ADDENDUM

NO. 1

PROJECT NAME: Tomball ISD Intermediate School Replacement

ADDENDUM DATE: Tuesday, July 28, 2026

1 ENLARGED PLAN - LEARNING STAIR - LEVEL 1
1/4" = 1'-0" BACK REF: A1.1C

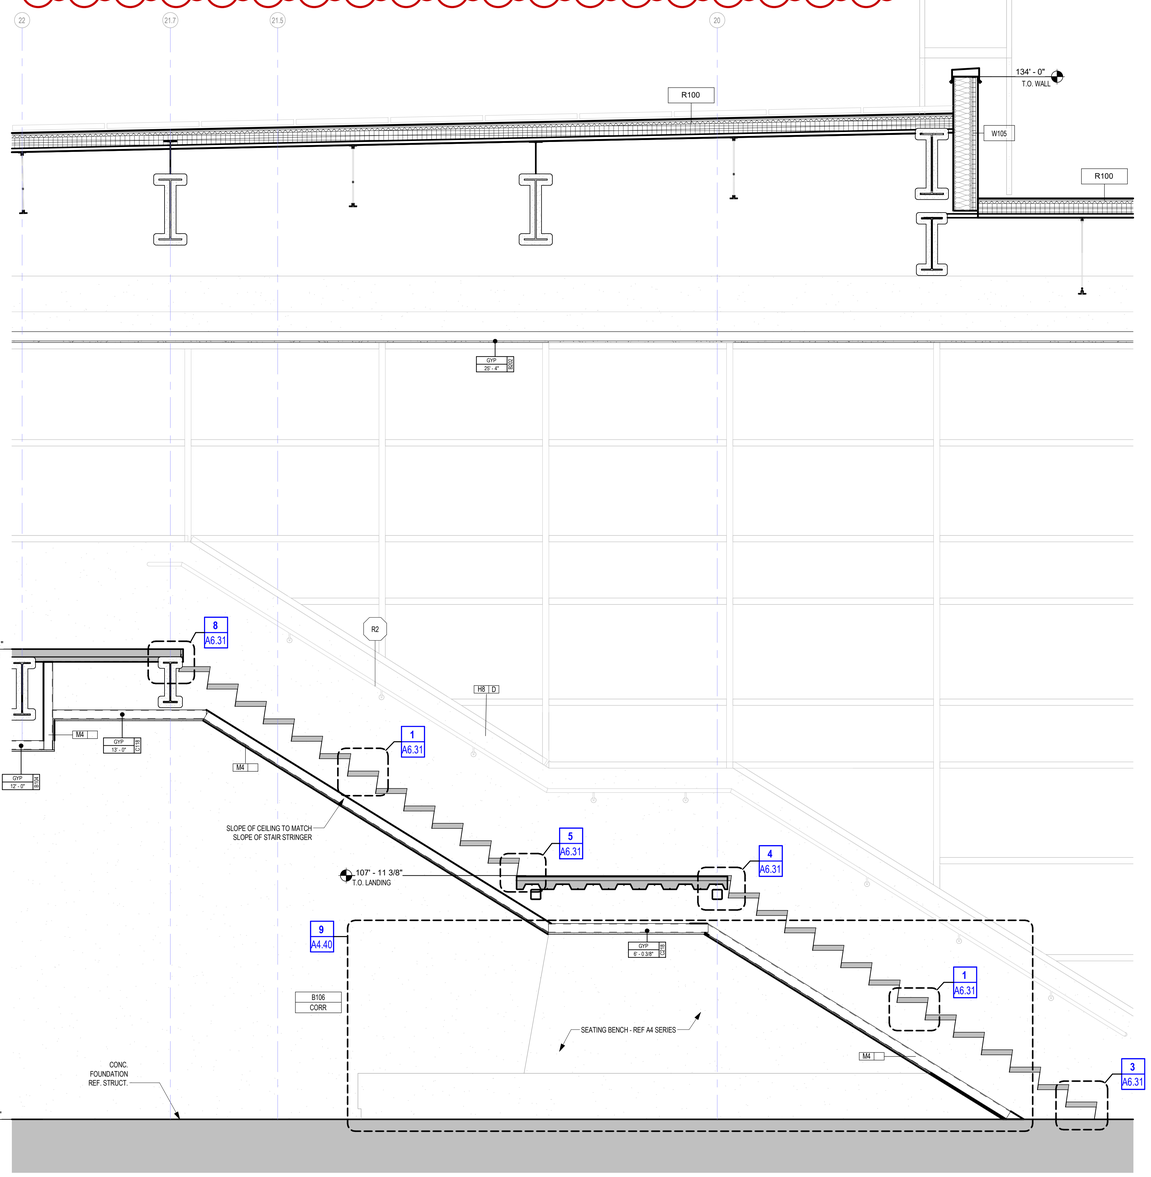
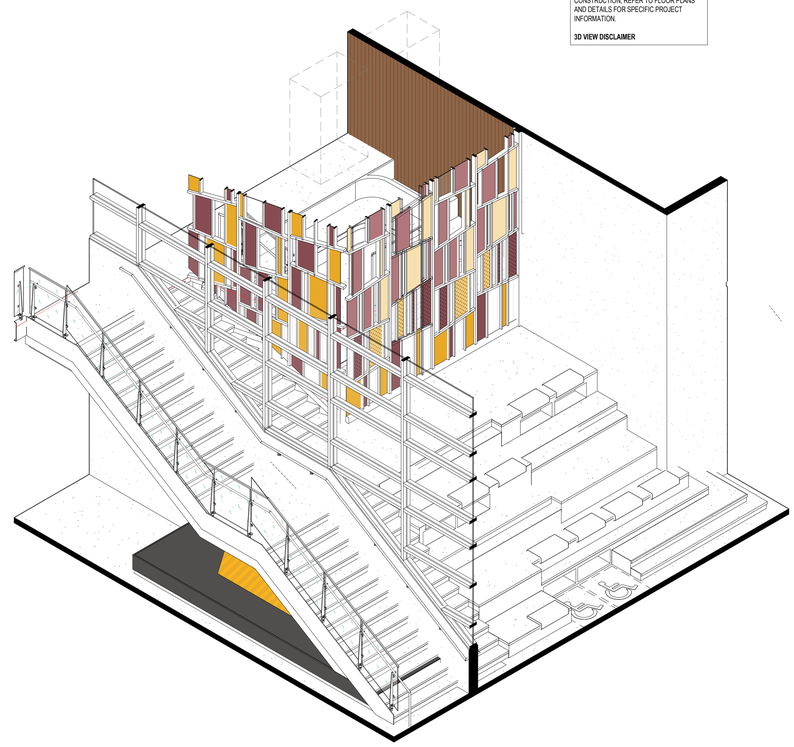
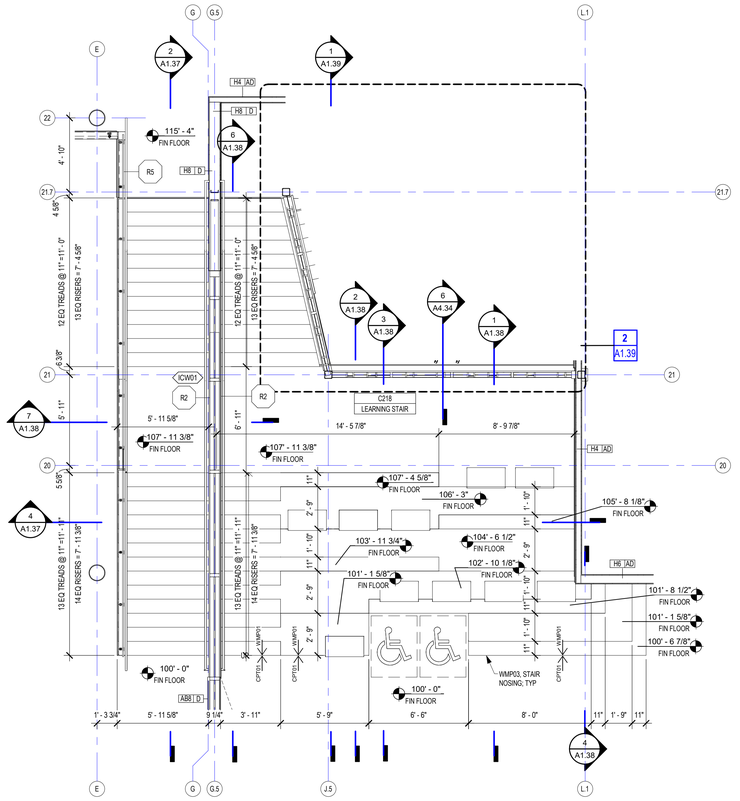
AD No 1, Arch. Item 4: **To the Drawings, Sheet A1.37,"LEARNING STAIRS"**
Added view 4/A1.37.

1 SECTION - LEARNING STAIR 7
1/2" = 1'-0" BACK REF: A1.37

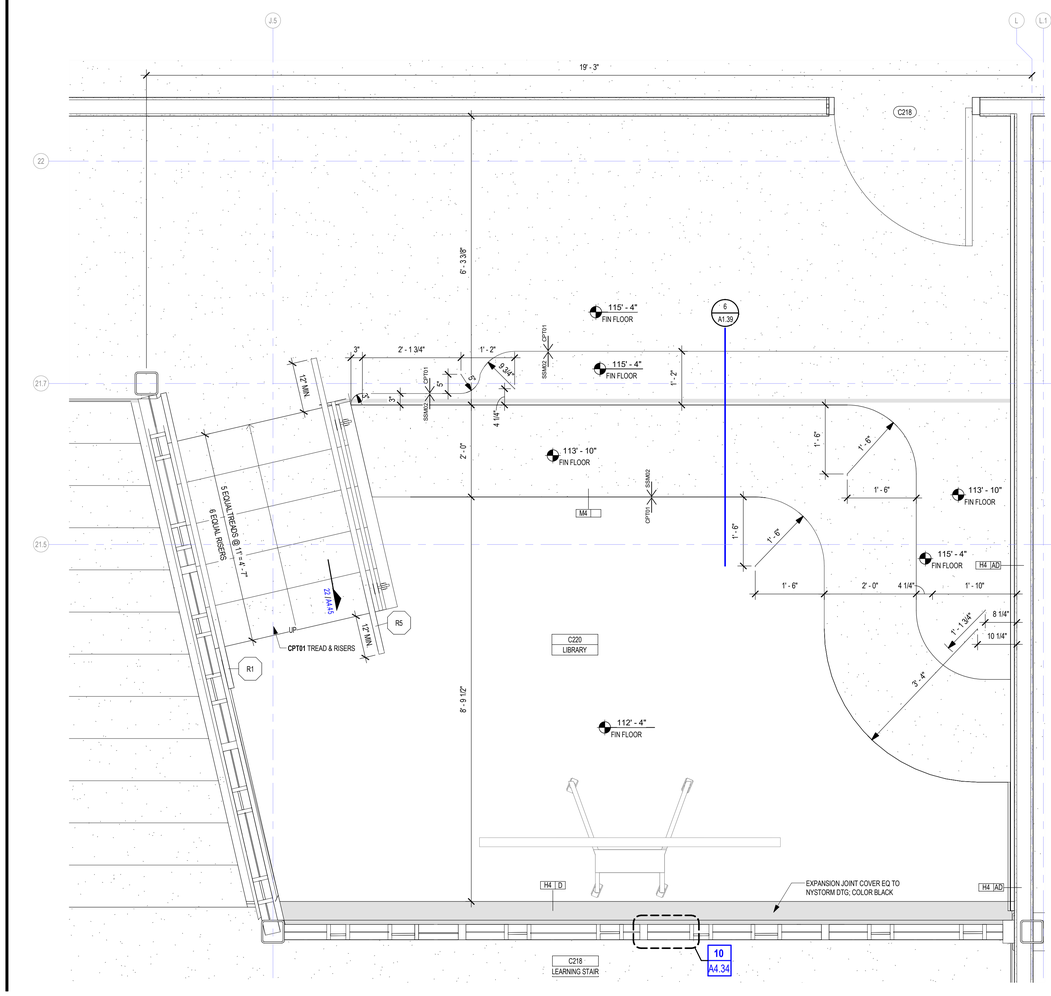
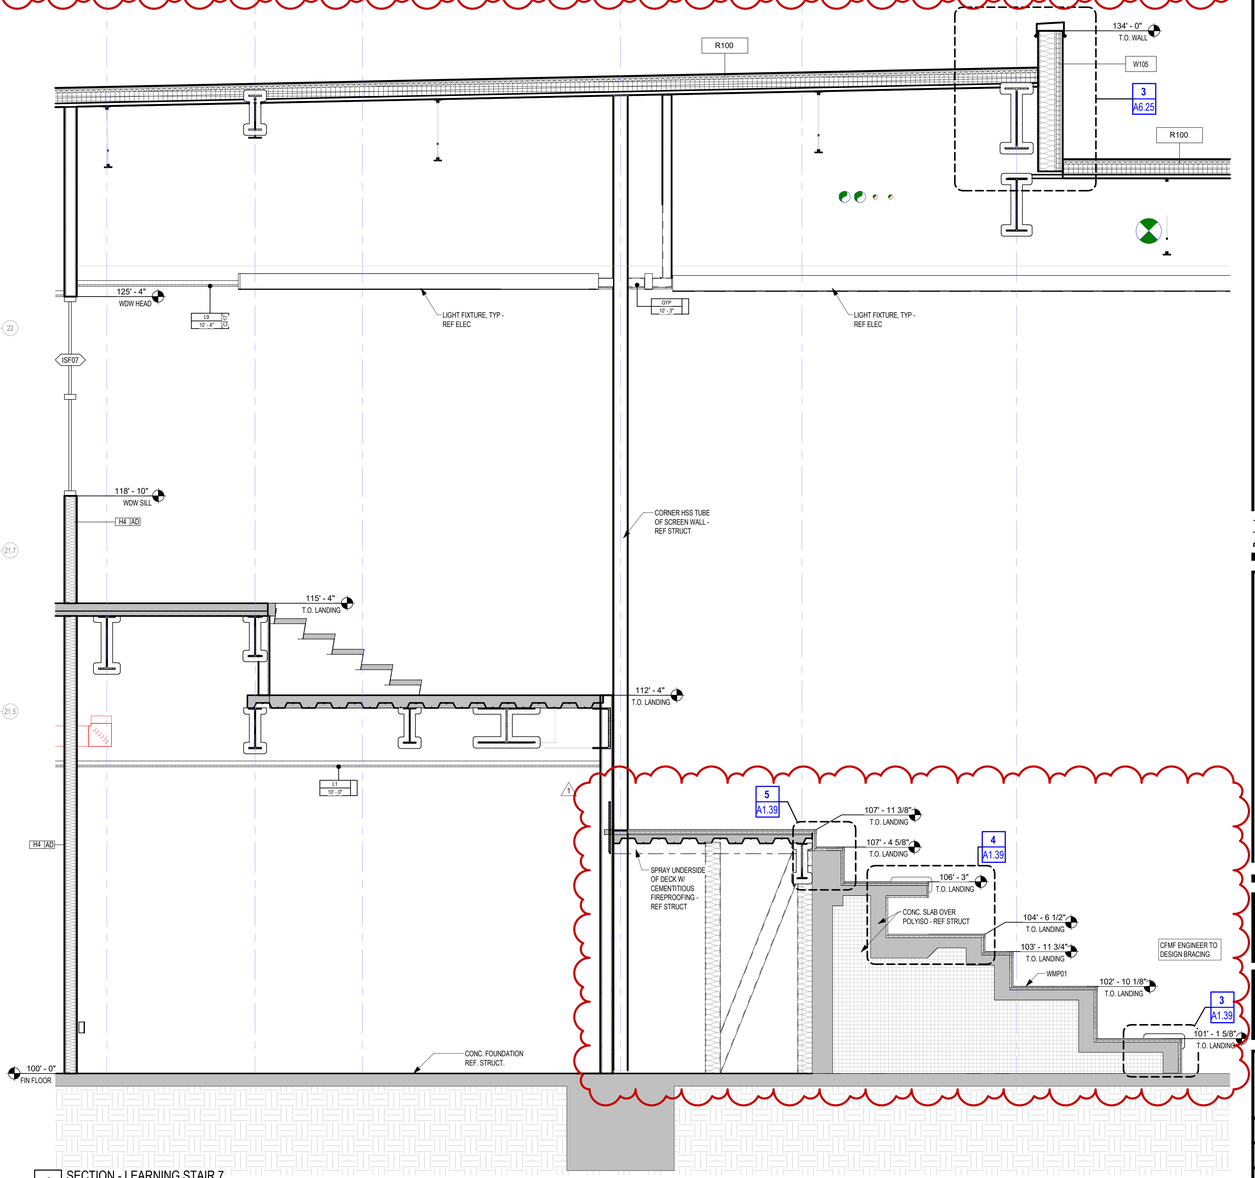
AD No 1, Arch. Item 6: **To the Drawings, Sheet A1.39,"LEARNING STAIRS"**
Updated views 1, 3, 4, 5, & 7 to show the construction of the learning stairs to be concrete slab over polyiso in coordination with structural.

1 MASTER REFLECTED CEILING PLAN - LEVEL 01
1" = 20'-0"

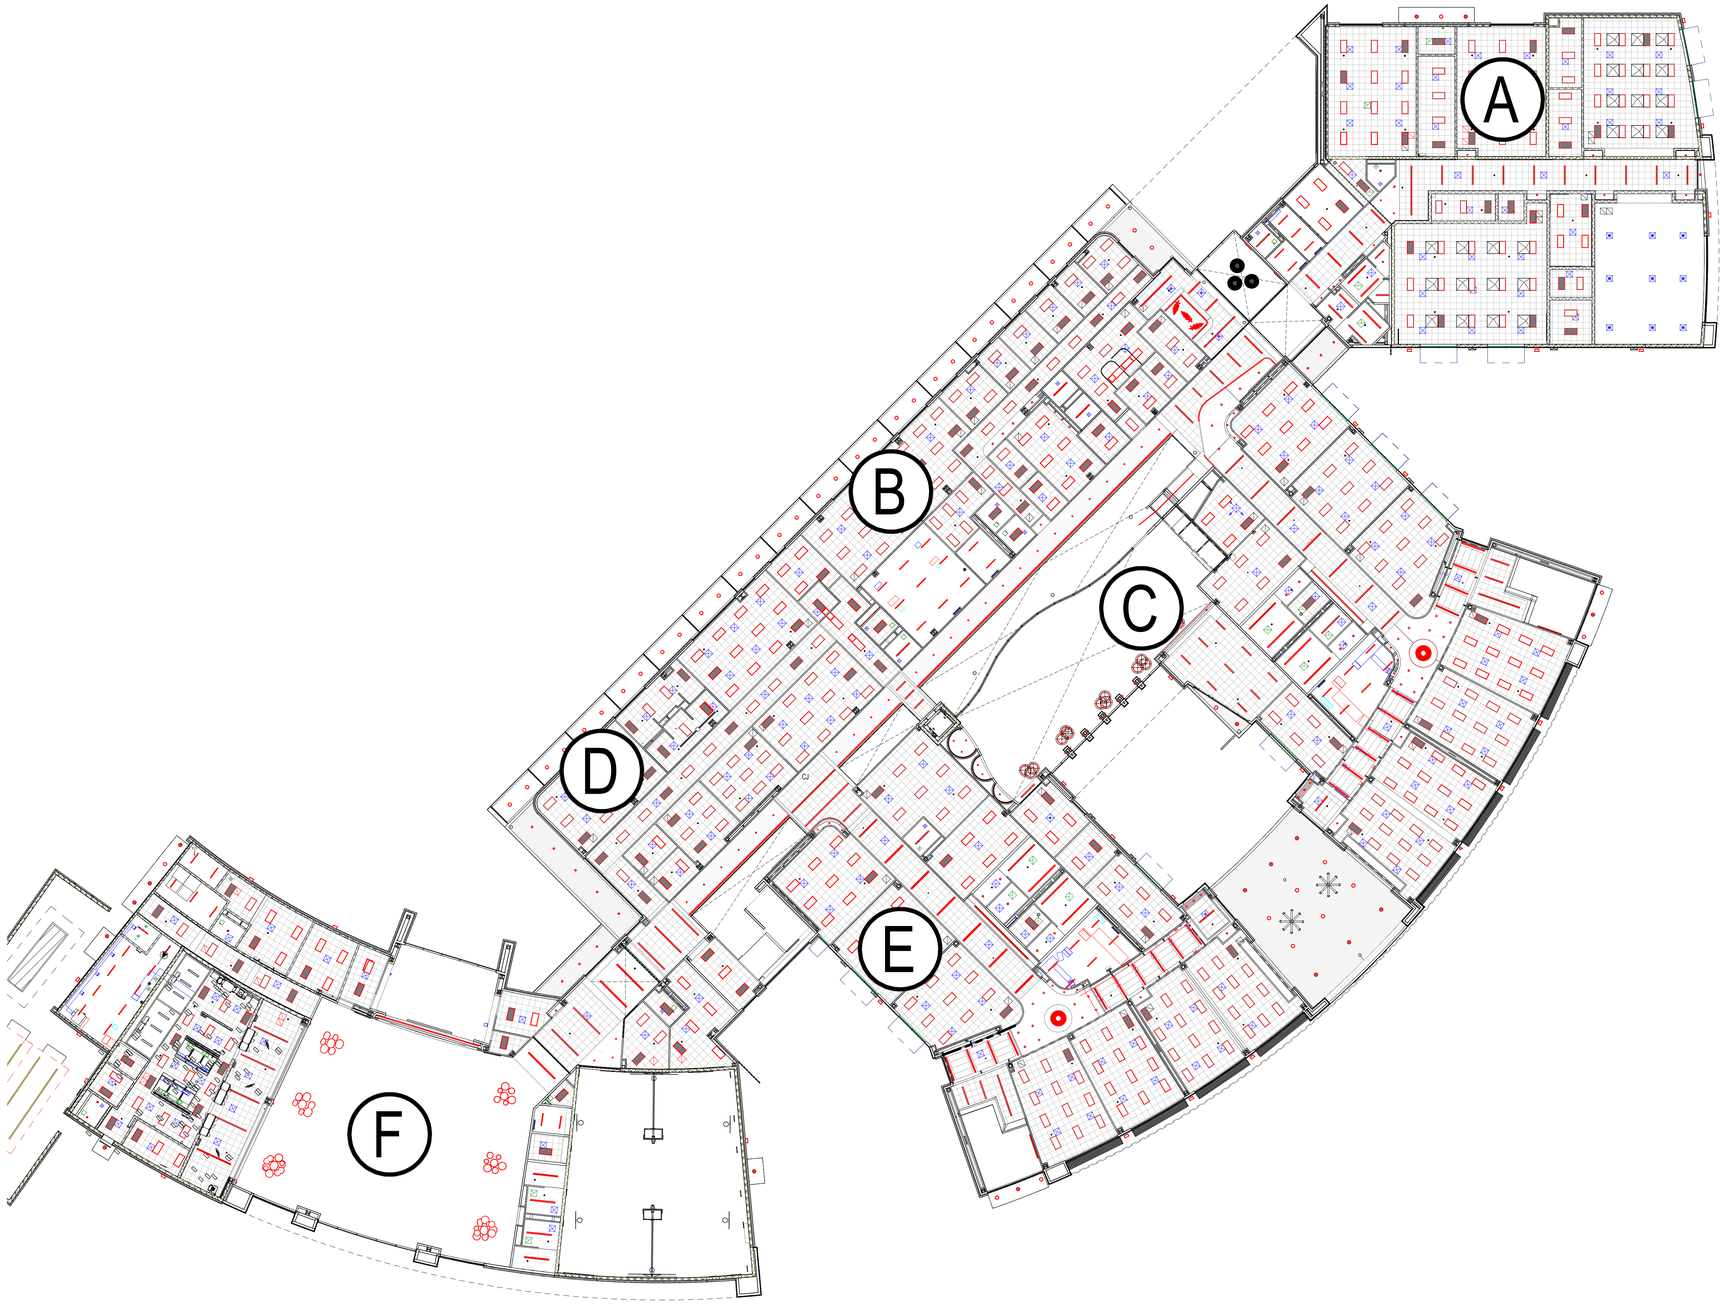
AD No 1, Arch. Item 8: **To the Drawings, Sheet A2.01,"MASTER REFLECTED CEILING PLAN – LEVEL 01"**
Added general note #6.

1 FINISH PLAN - LEVEL 02 - AREA B
1/8" = 1'-0"

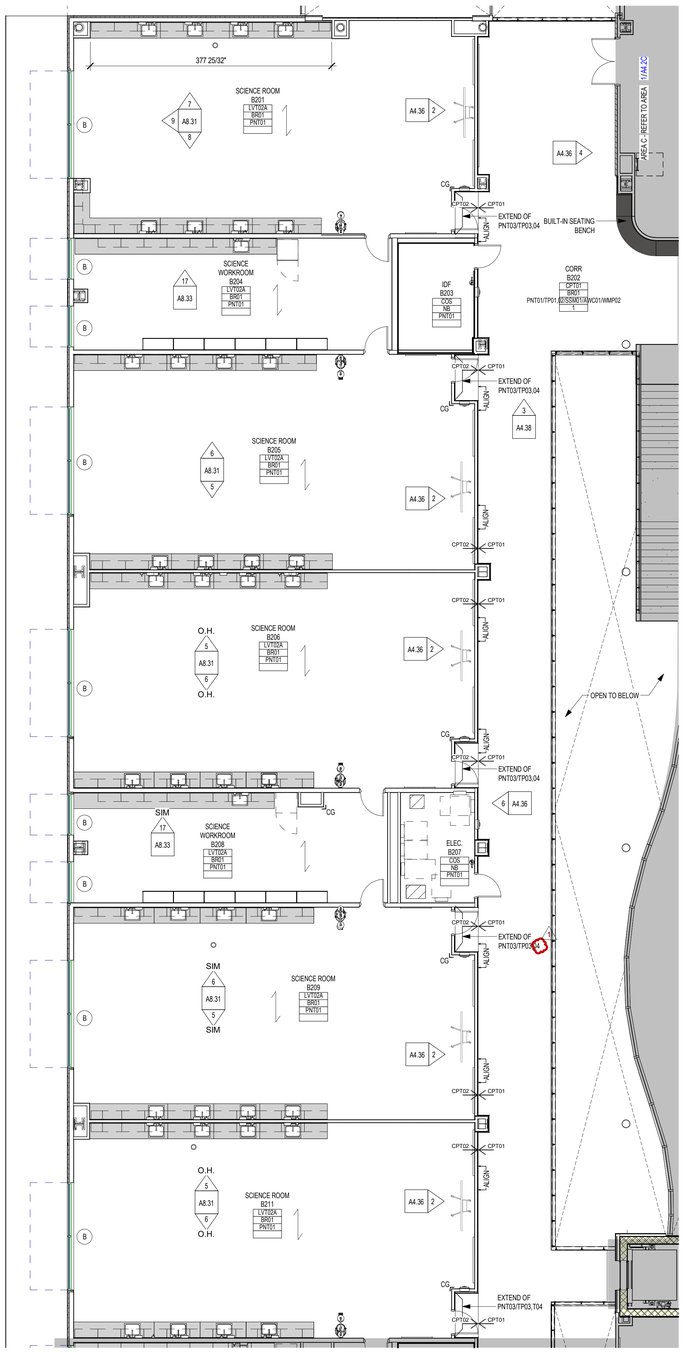
AD No 1, Arch. Item 12: **To the Drawings, Sheet A4.2B,"FINISH PLAN – LEVEL 2- AREA B"**
Revised tile annotation at alcoves. typical throughout project.
Revised FINISH PLAN GENERAL NOTES #10.

1 EQUIPMENT PLAN - LEVEL 02 - AREA B
1/8" = 1'-0"

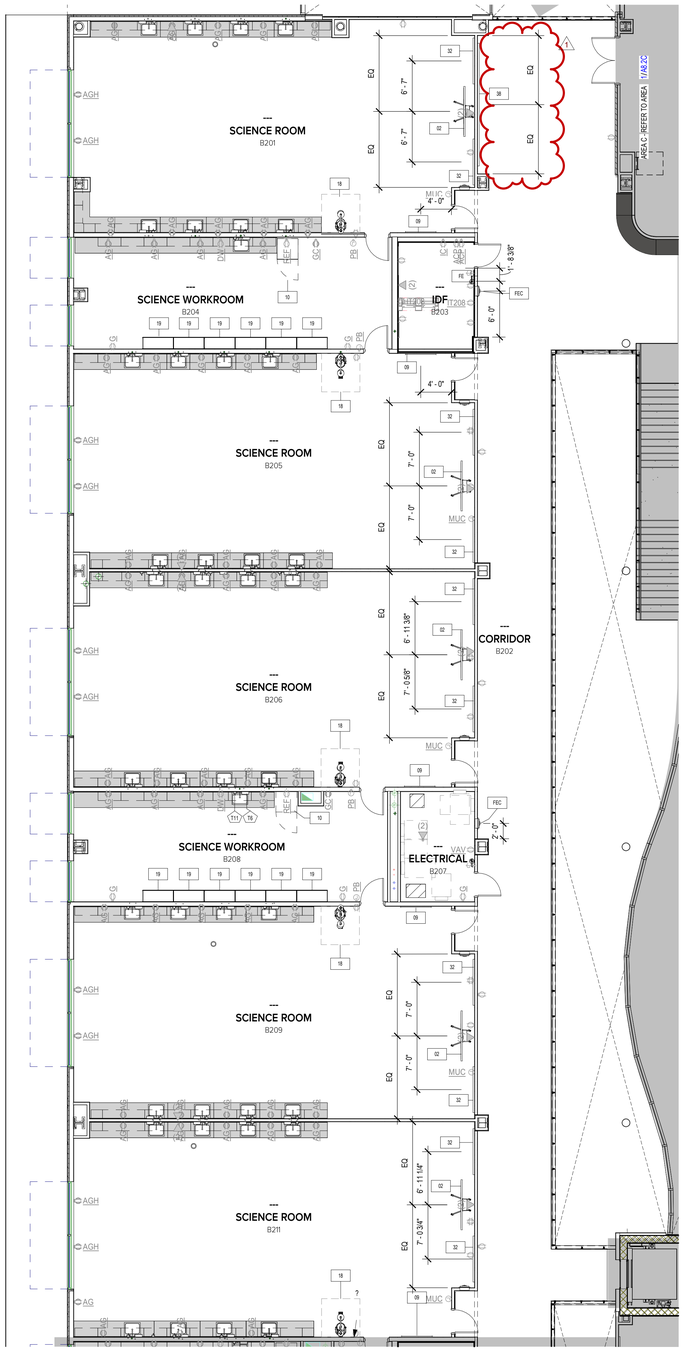
AD No 1, Arch. Item 19: **To the Drawings, Sheet A8.2B,"SIGNAGE AND EQUIPMENT PLAN – LEVEL 02 – AREA B"**
Added equipment item #38 to the equipment schedule and the plan.

1 PLUMBING PLAN - LEVEL 02 - AREA A
1/8" = 1'-0"

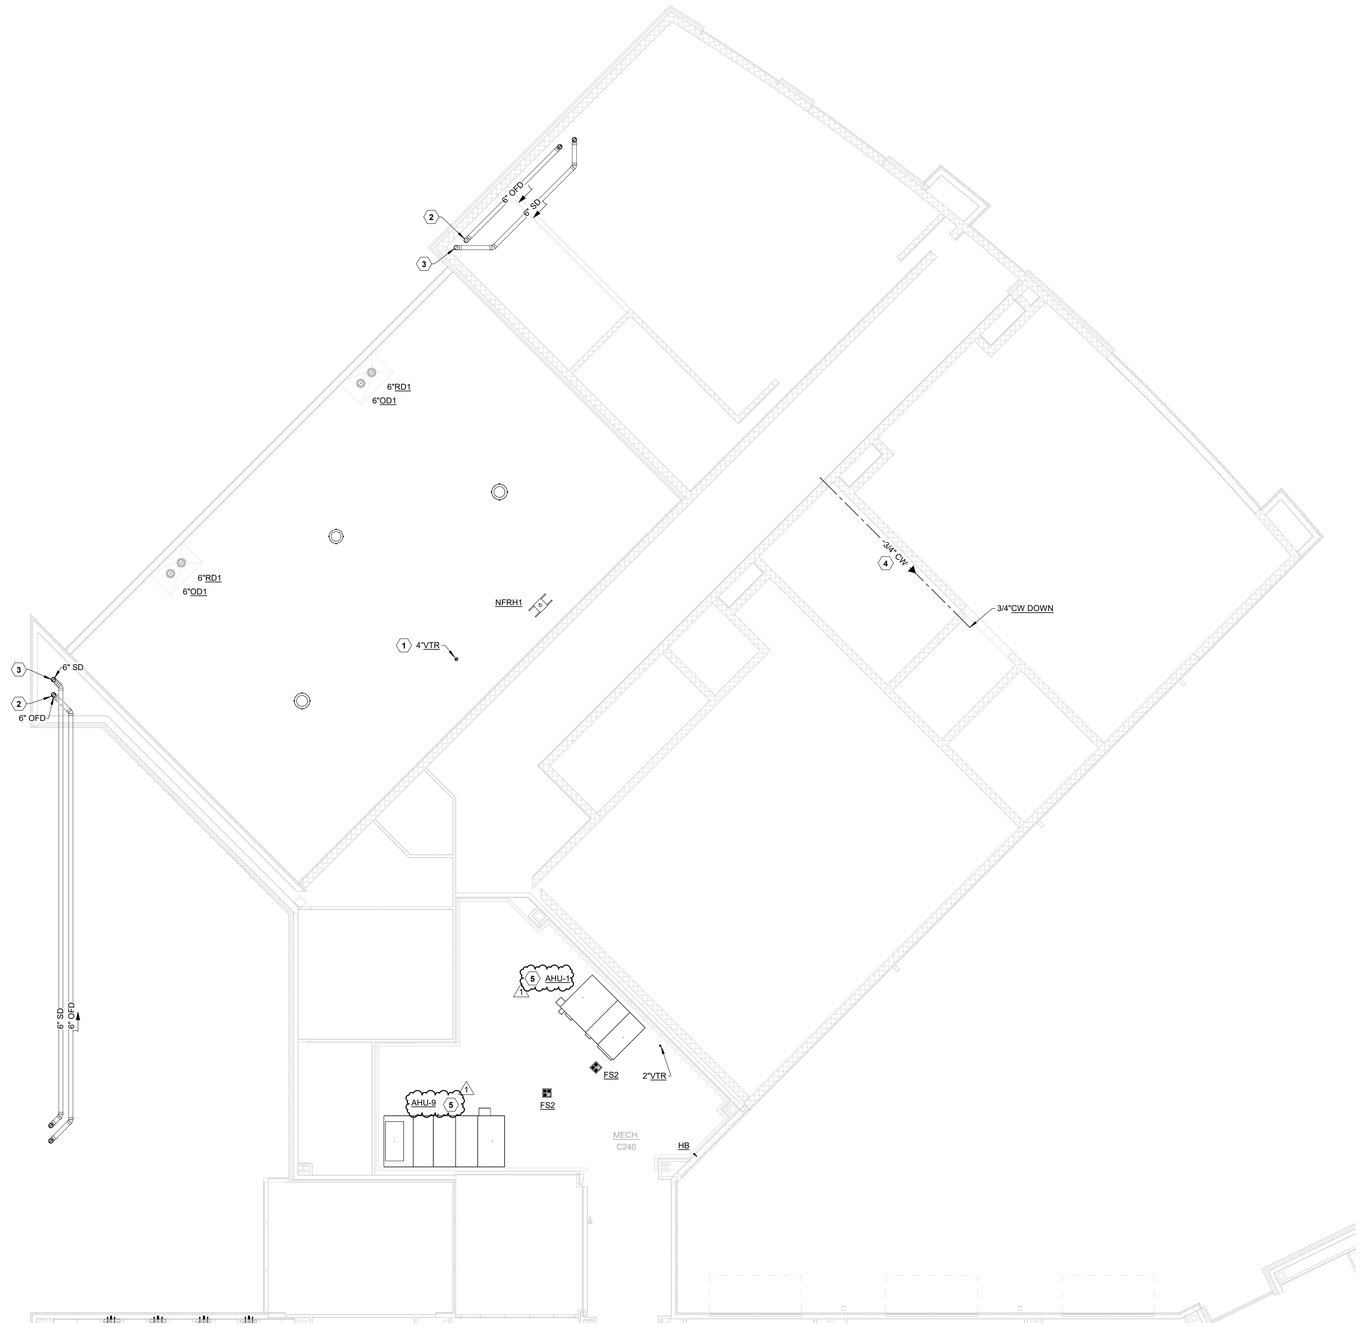
AD No 1, Plumb. Item 10: To the Drawings, Sheet P2.2A,"PLUMBING PLAN – LEVEL 02 – AREA A"

1) Added keynote 5.
